Office Action Summary	Application No. 10/773,346	Applicant(s) JAEGER, JOHN C.	
	Examiner Anu Ramana	Art Unit 3733

DETAILED ACTION

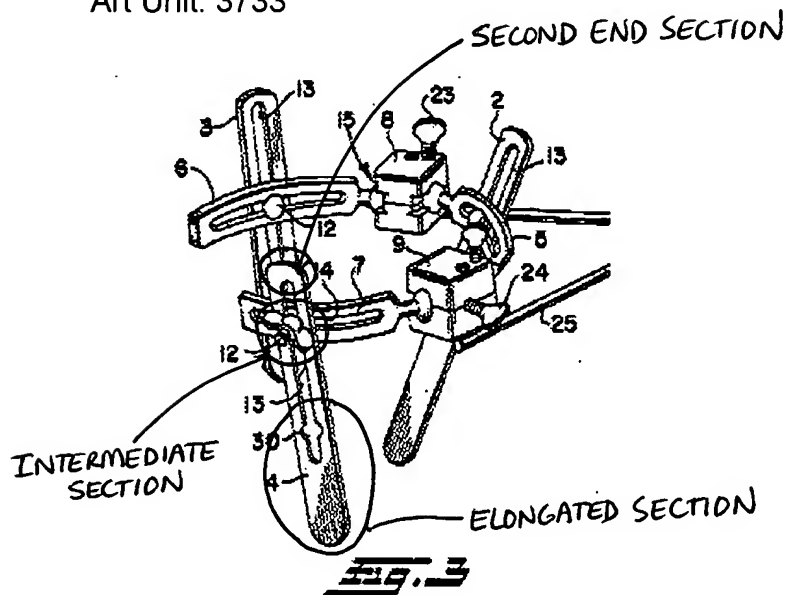
Karlin et al. disclose a retractor including: a support frame; at least three blades (2, 3, 4); and means (12) mounted on the frame and engageable by a section of each blade (Fig. 1, col. 2, lines 55-72, cols. 3-4 and col. 5, lines 1-53). See marked up Fig. 1 on the following page.

Regarding claim 10, Karlin et al. disclose a plurality of blocks 8 and 9, each of which interact with a respective end section of a respective blade by means of members 5, 6 and 7.
